City of Aurora Building Division
Project: Revisions To One Line
Address: 12251 E. Cornell Ave.
Occupancy Group: IBC R-2
Construction Type: IBC VB-SPK
RSN: 1411585
Permit: 19-1711111

CORNELL SENIOR APARTMENTS
12251 E. CORNELL AVE.
AURORA, CO 80014

ELECTRICAL ONE LINE DIAGRAM

### ELECTRICAL UNIT PLANS

ONE LINE DIAGRAM

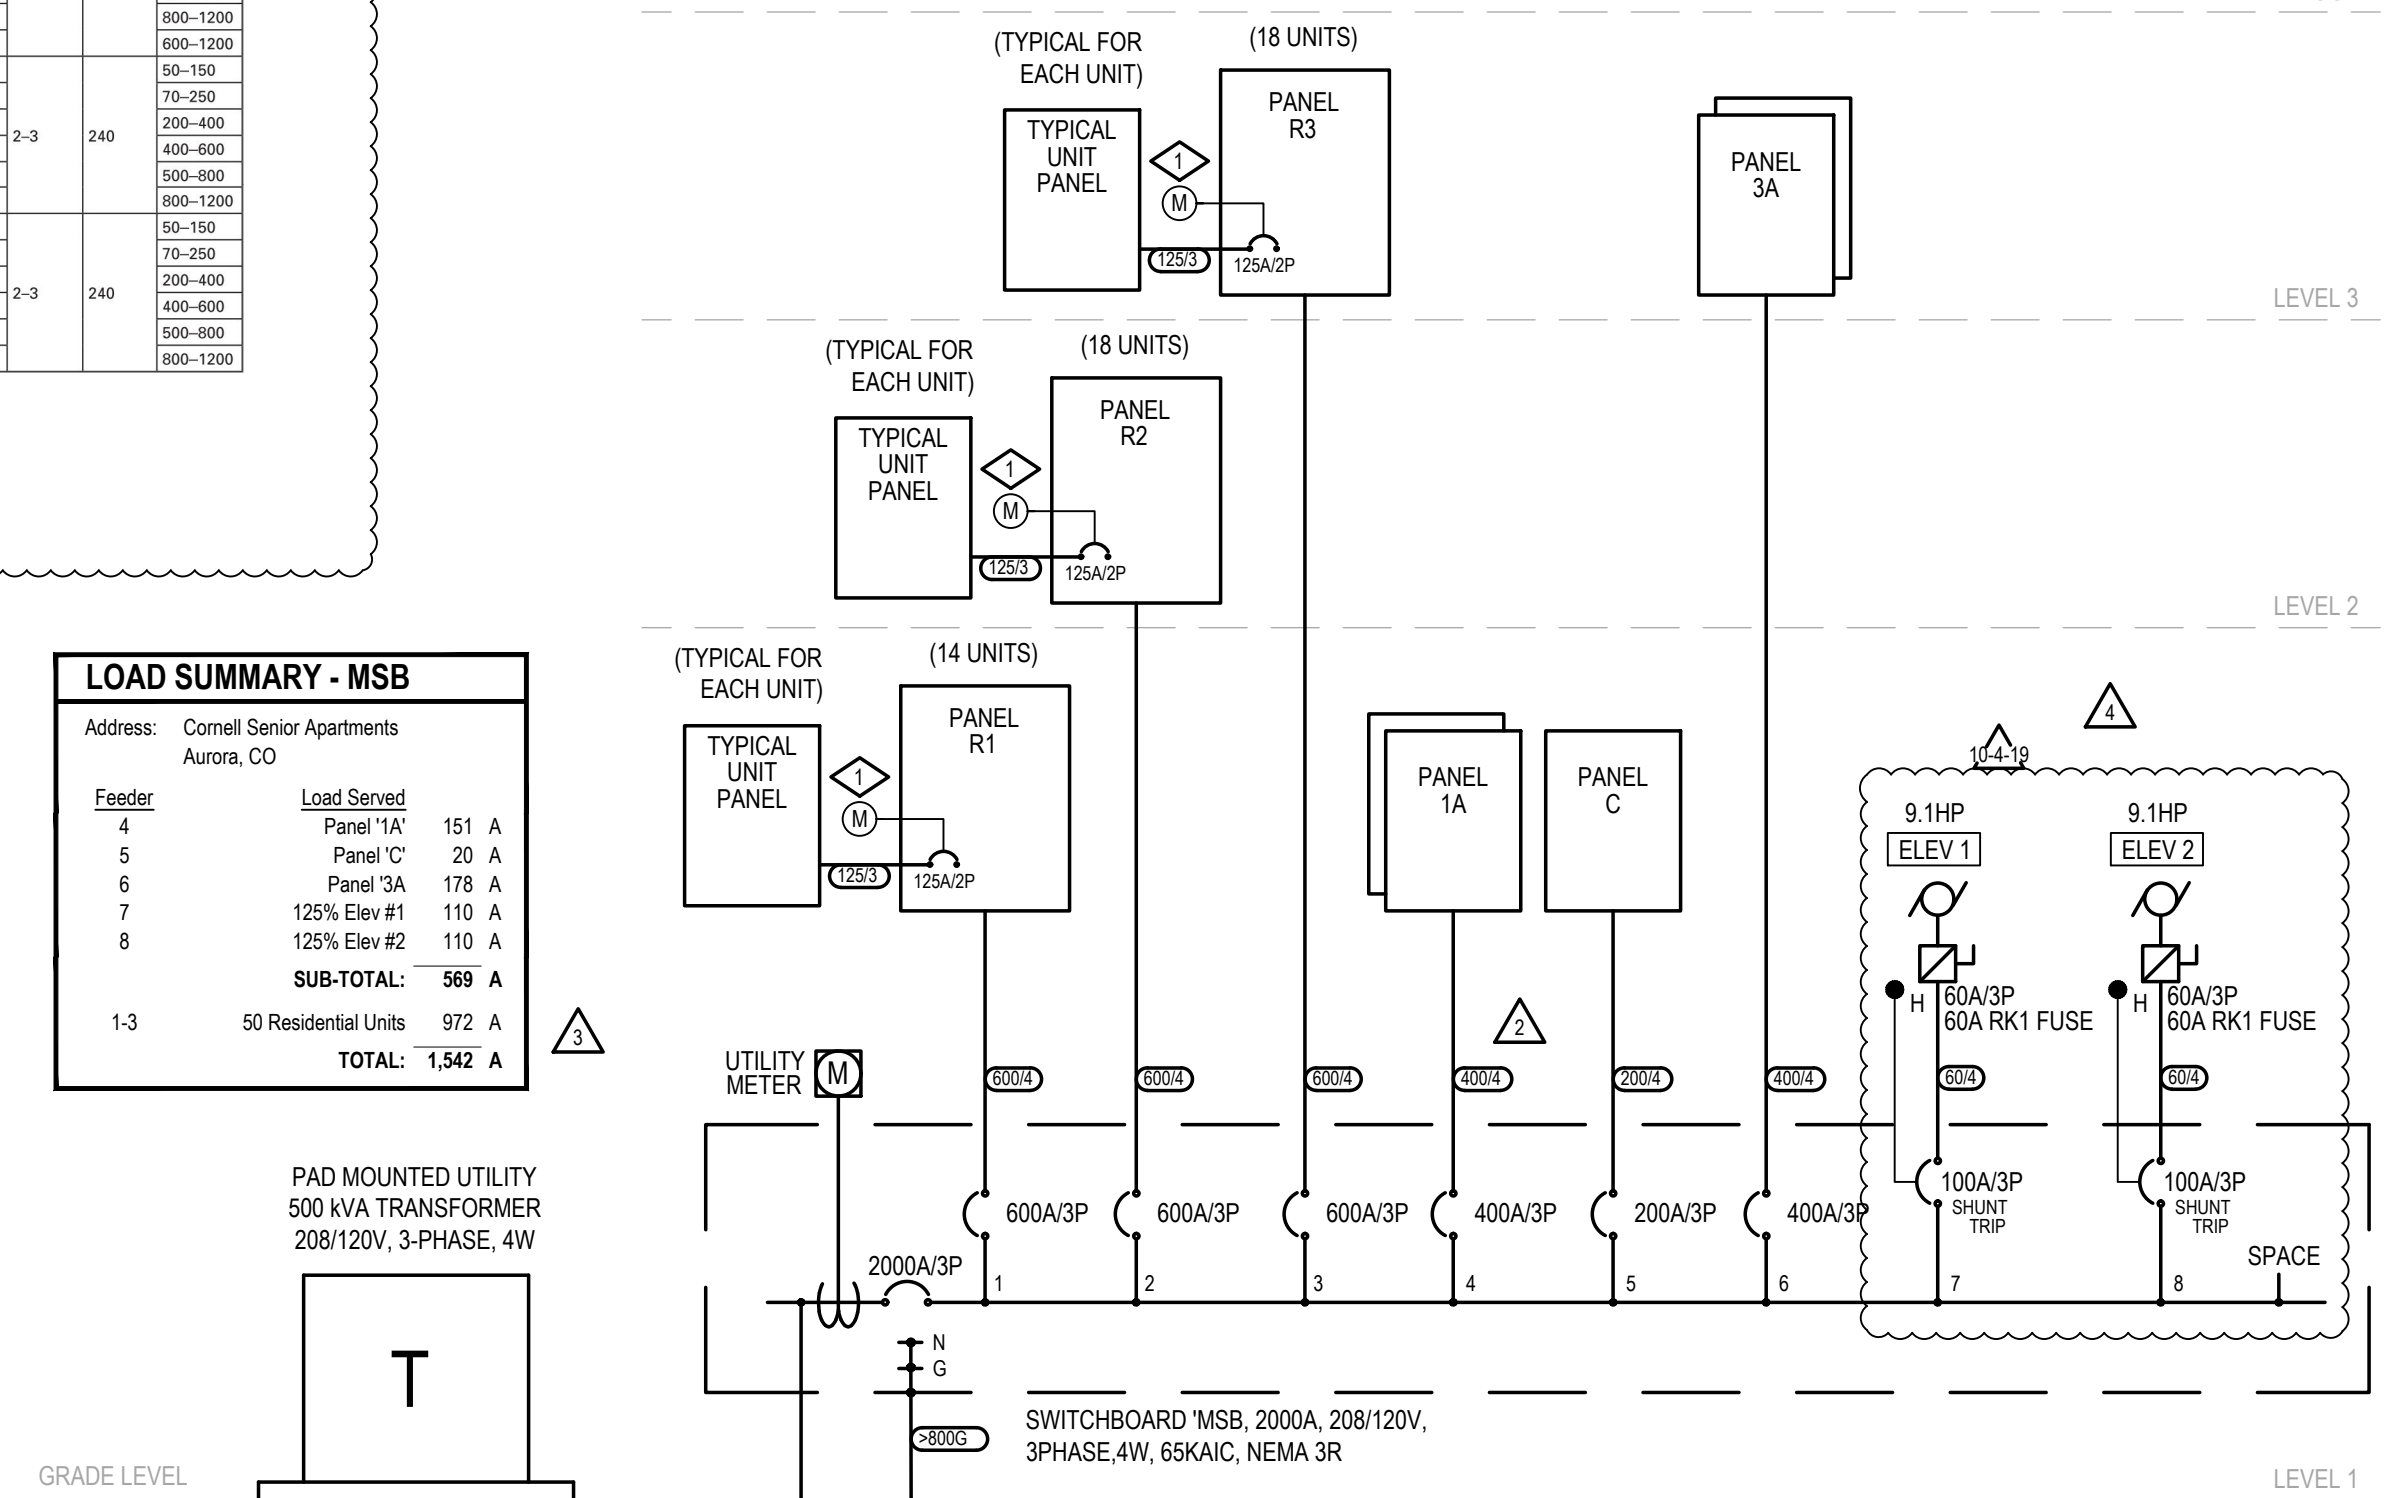
Service Equipment shall be permanently and legibly marked to show the available fault current and date the calculation was performed. 2017 NEC 110.24(A)(B).

Provide a Grounded Electrode System bonded to the service equipment enclosure, grounded conductors, and grounded electrode conductors per 2017 NEC 250.50 and 250.104.

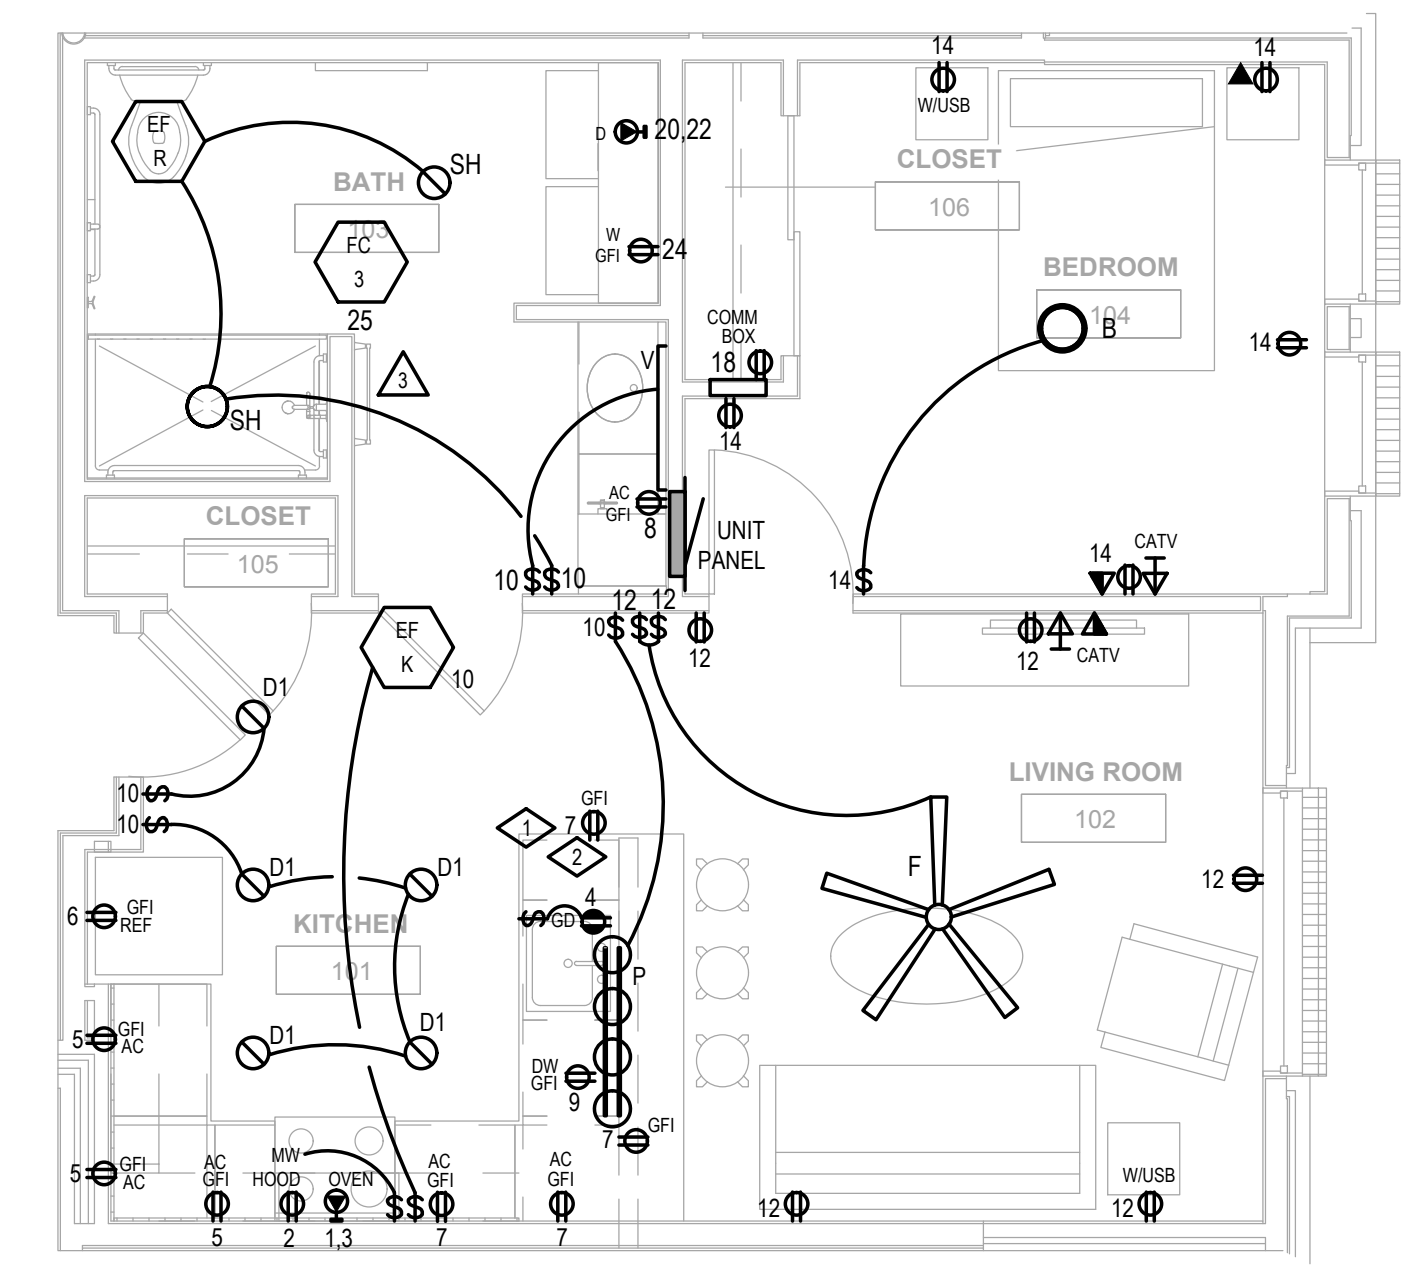
Service Equipment shall be permanently and legibly marked to show the available fault current and date the calculation was performed. 2017 NEC 110.24(A)(B).

Every circuit and circuit modification shall be legibly identified as to it's clear, evident and specific purpose or use. The identification shall include an approved degree of detail that allows each circuit to be distinguished from all others. 2017 NEC 408.4

**PANEL SCHEDULE: Typical 2BR** October 4, 2019

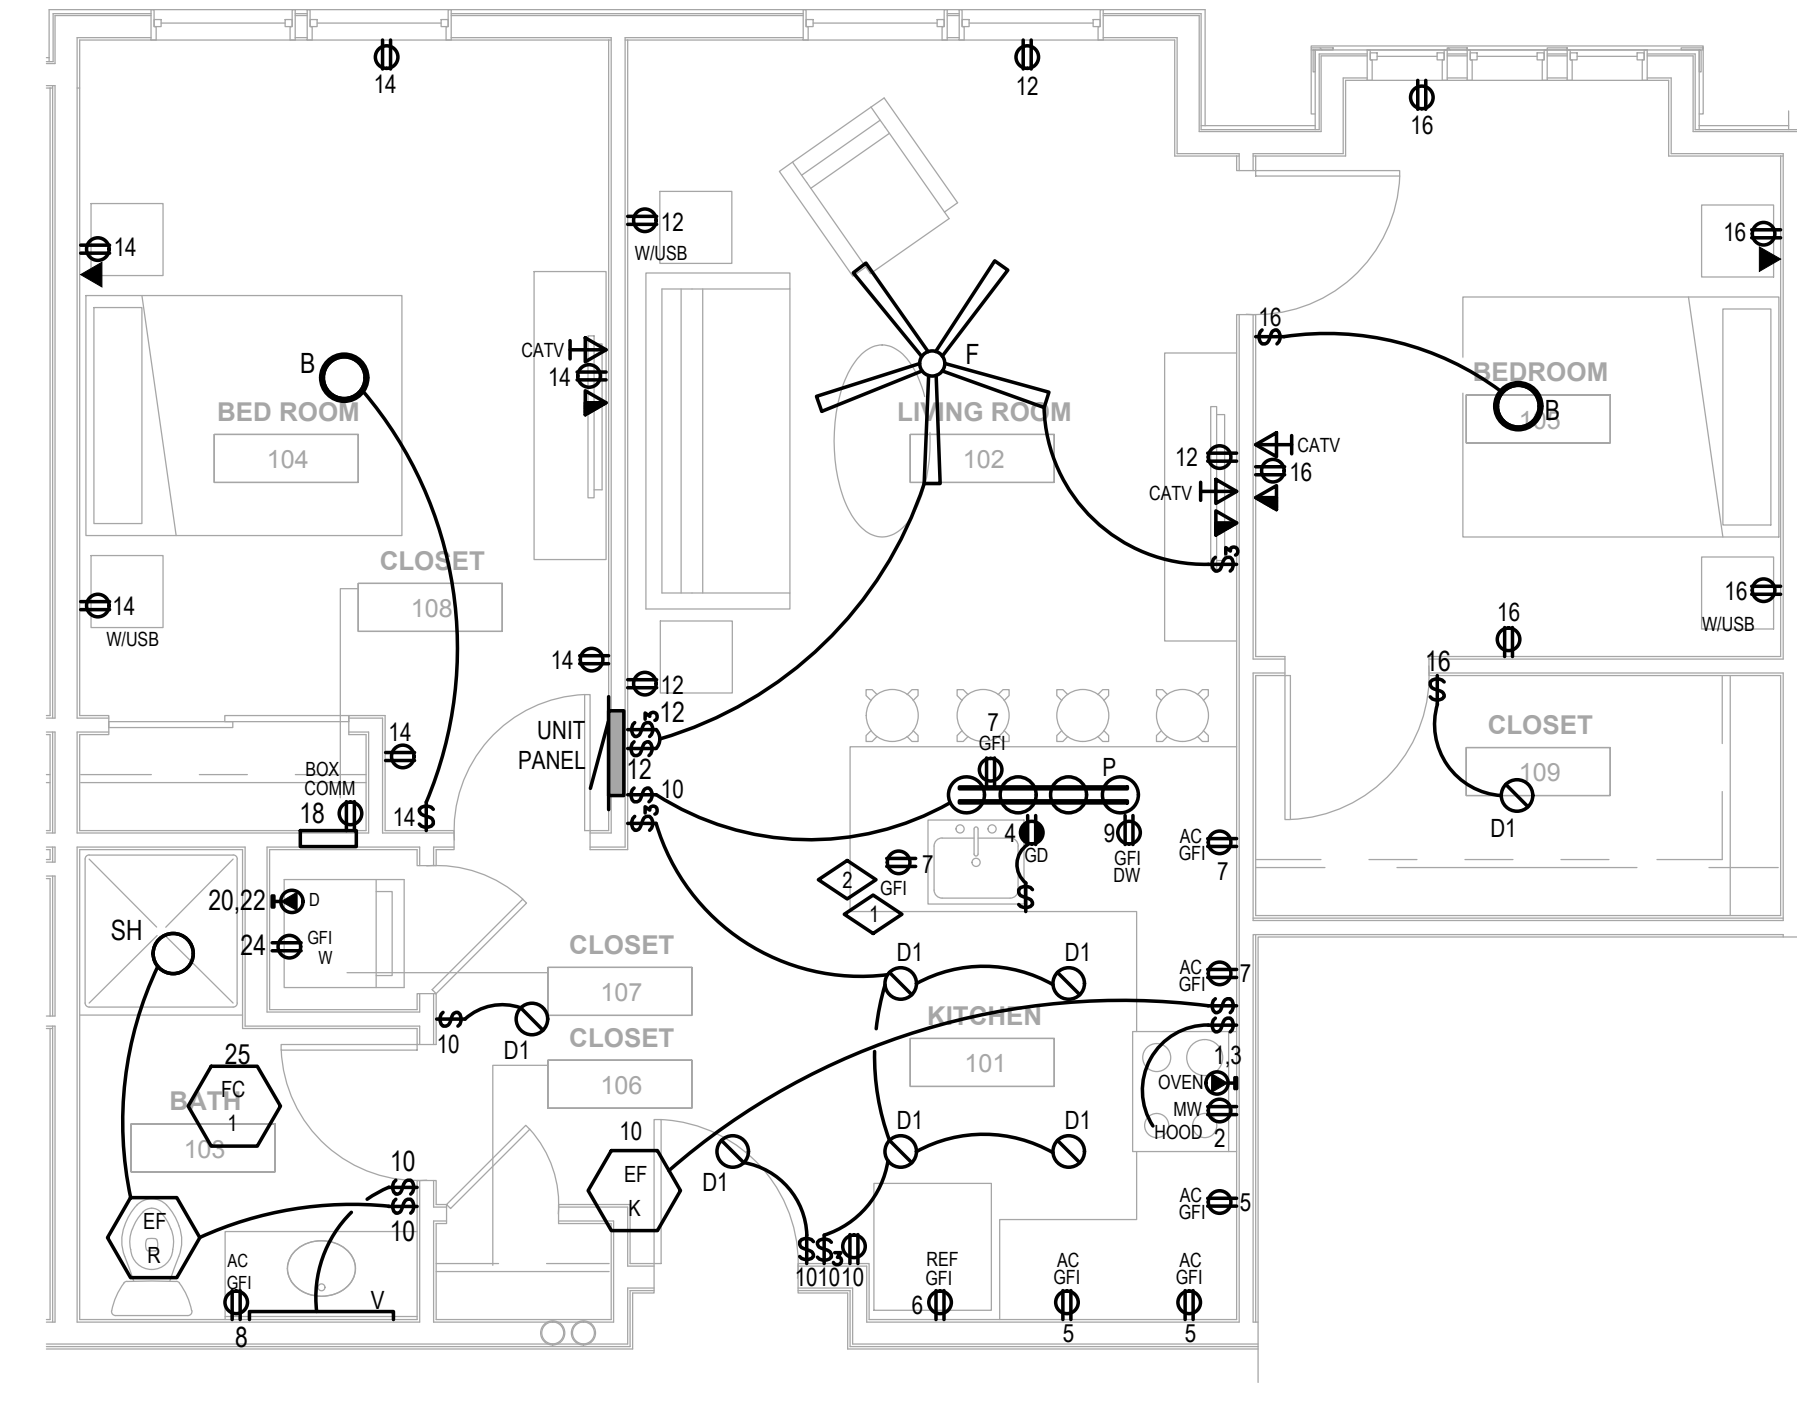
Service Equipment shall be permanently and legibly marked to show the available fault current and date the calculation was performed. 2017 NEC 110.24(A)(B).

Every circuit and circuit modification shall be legibly identified as to it's clear, evident and specific purpose or use. The identification shall include an approved degree of detail that allows each circuit to be distinguished from all others. 2017 NEC 408.4
